Request to Modify John Kimbrough Blvd. Pickard Pass

Clint Willis, Manager
Transportation Services
CBE Design Review Committee Meeting
Oct. 28, 2020

TEXAS A&M UNIVERSITY

Modifications to Passageway and Intersection

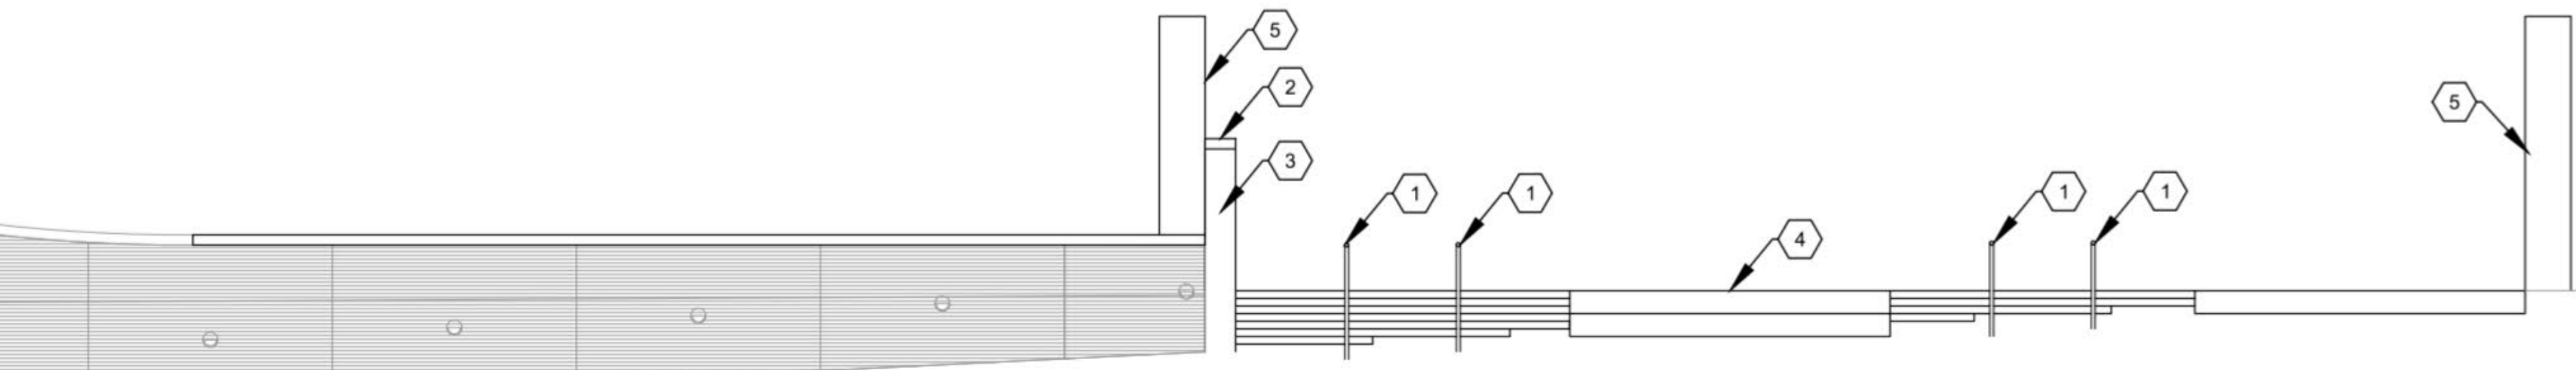
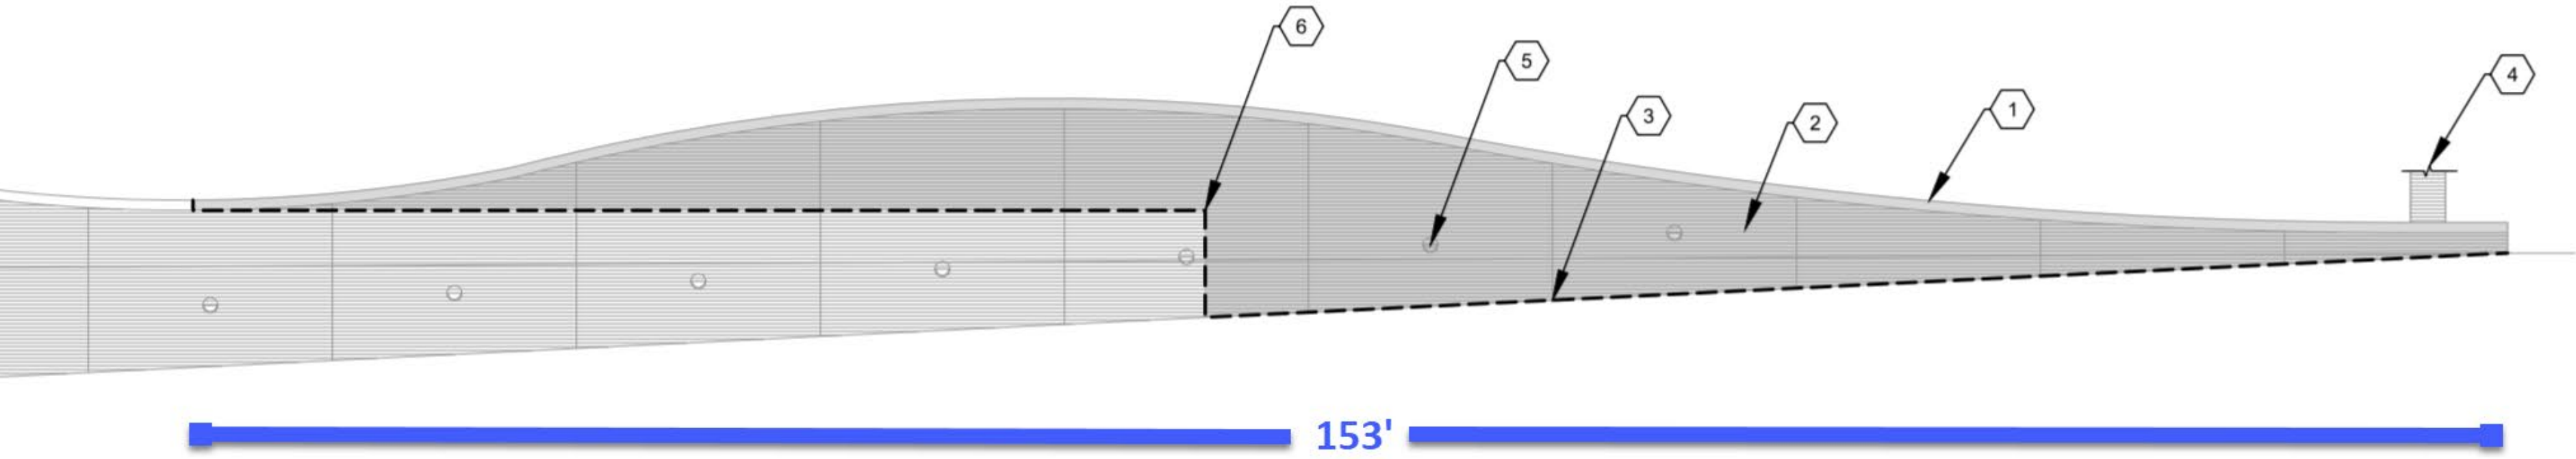
- Opening entrances to the passageway to improve sight lines
- Adding landscape to channelize pedestrians
- Realigning the drive to Lot 61
- Building a masonry and iron fence to channelize pedestrians to new mid-block crossing between Lot 61 and the passageway
- Removing one Live Oak tree at the entrance to Lot 61; adding 19 crepe myrtle trees
- Providing new campus standard lighting and additional campus standard wayfinding signage
- Improving the turn lanes leading to the West Campus Garage
- Alternate options available to remove maroon topped light towers and replacing them

East End of Passageway

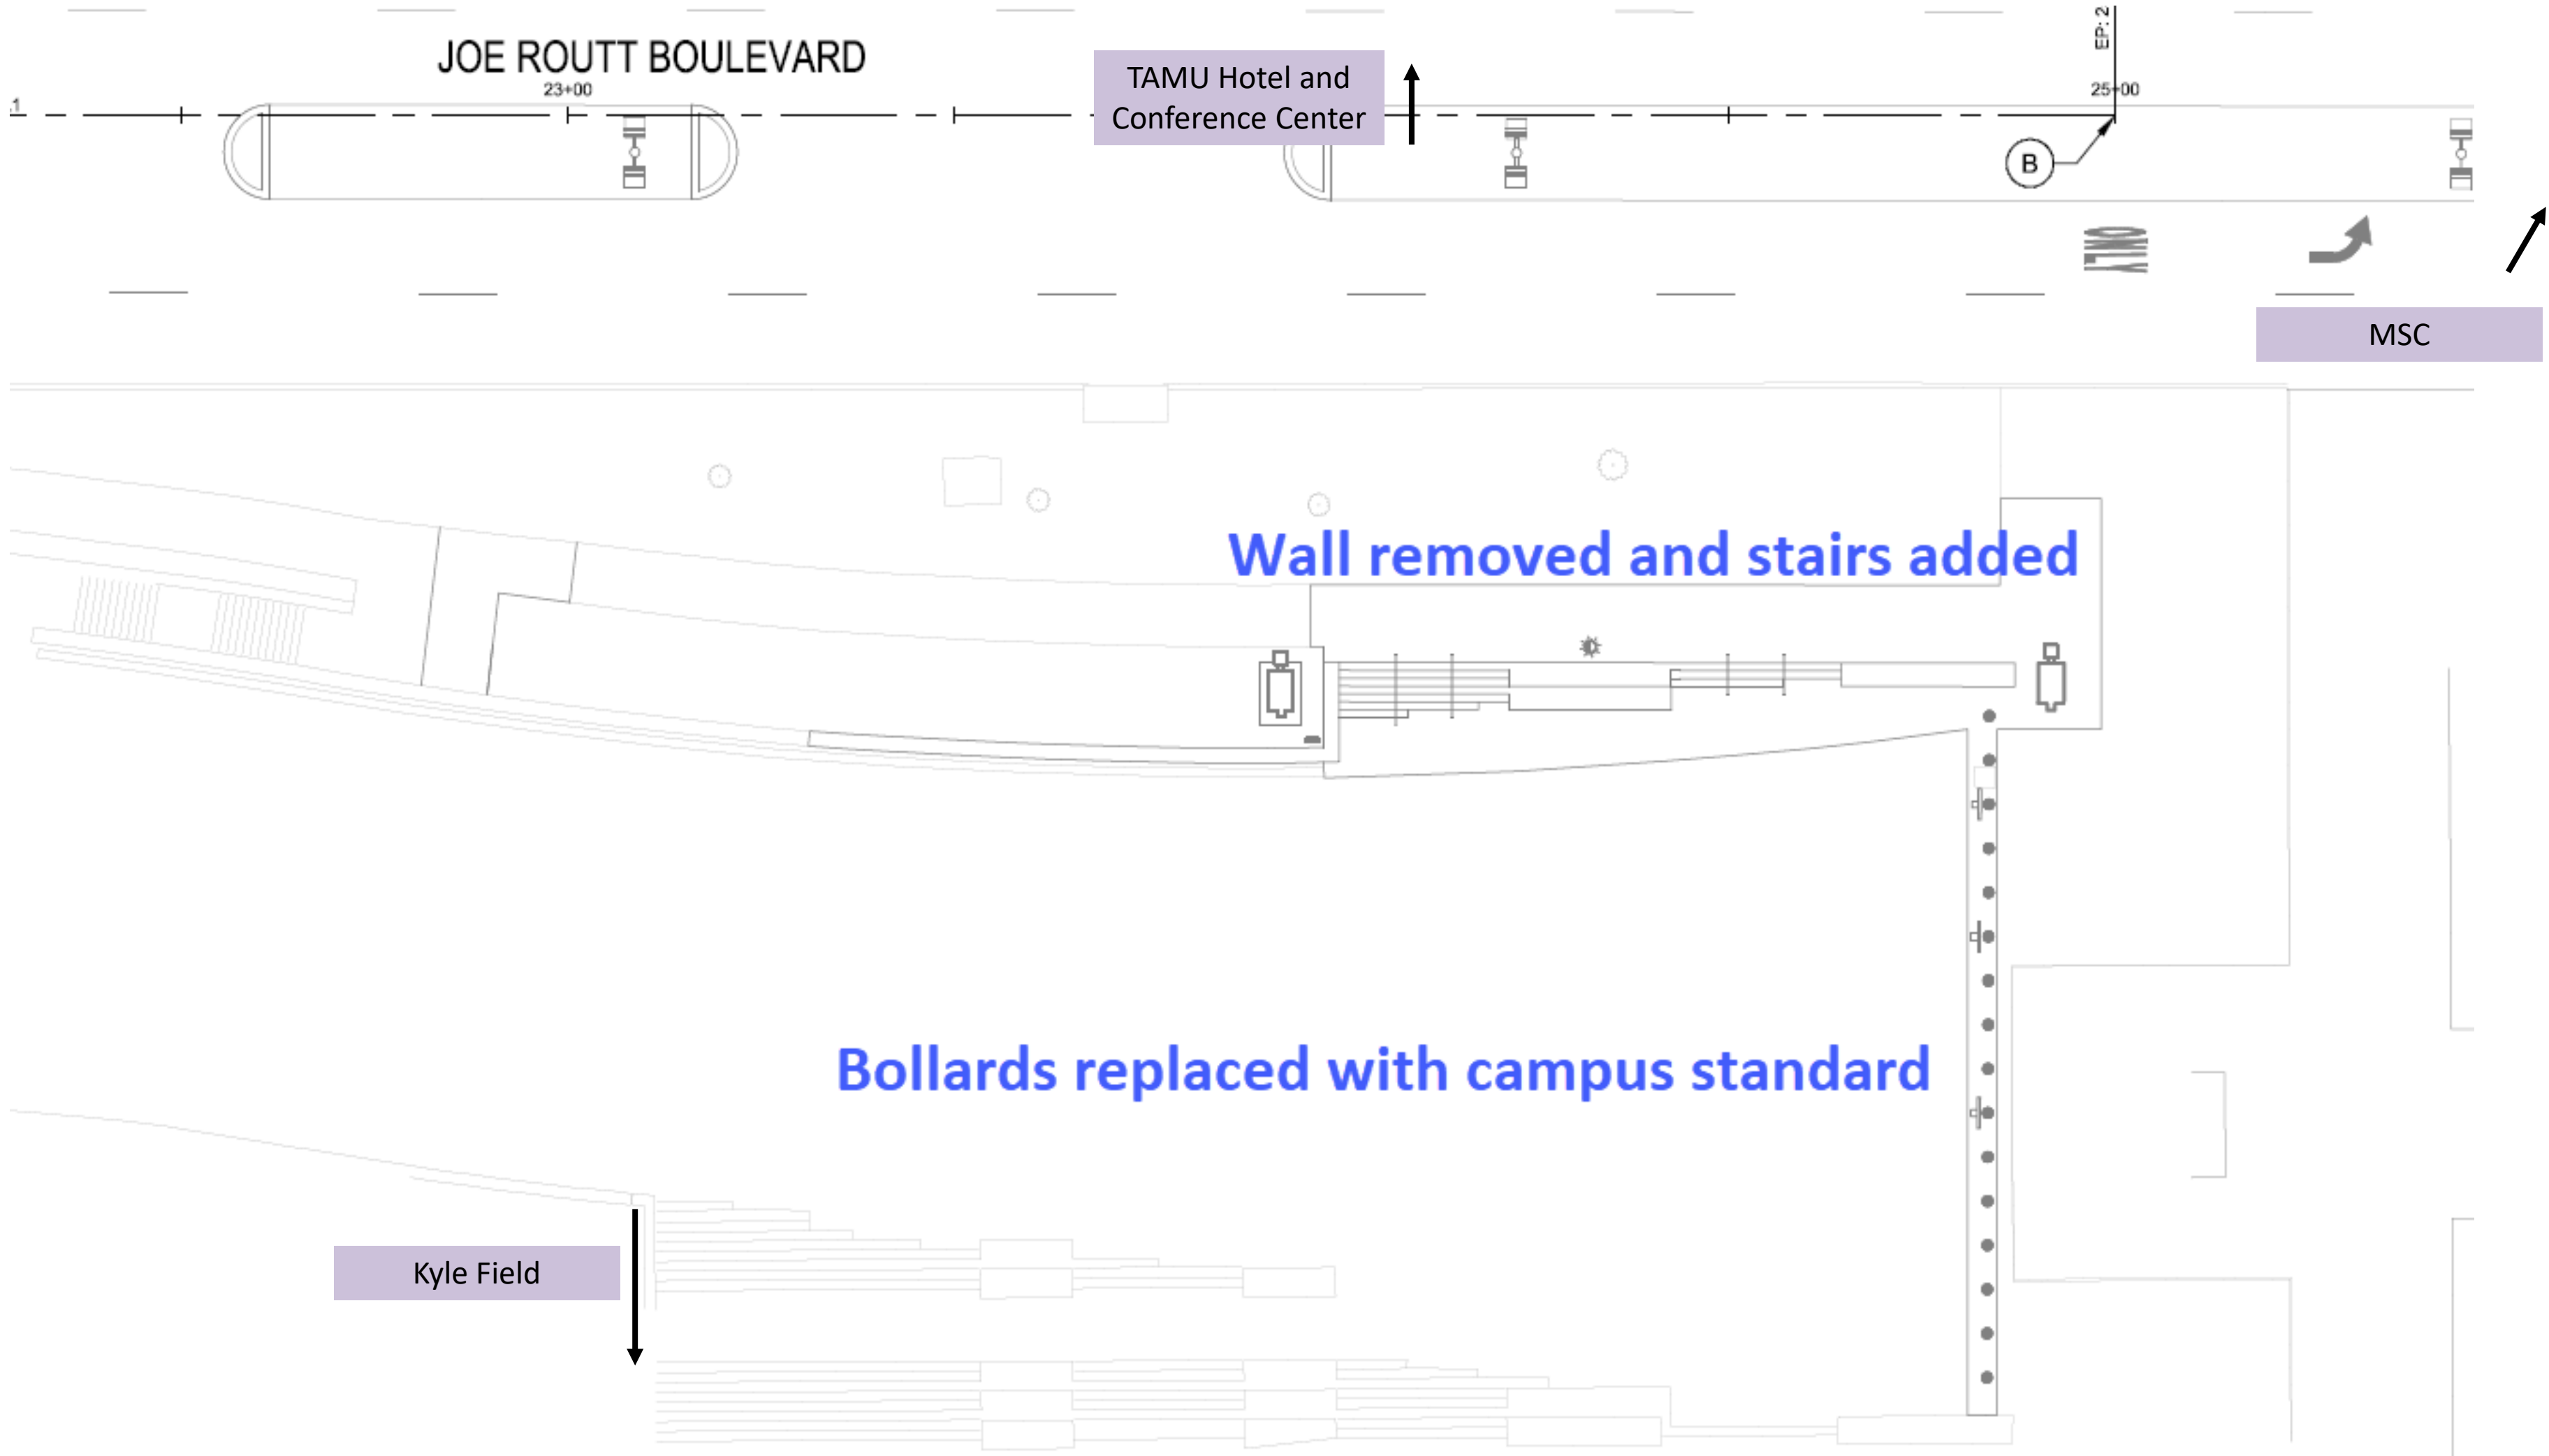
The project removes segment of wall, adds steps and extends these landscaping elements to the west

Wall removed and stairs added

Bollards replaced with campus standard
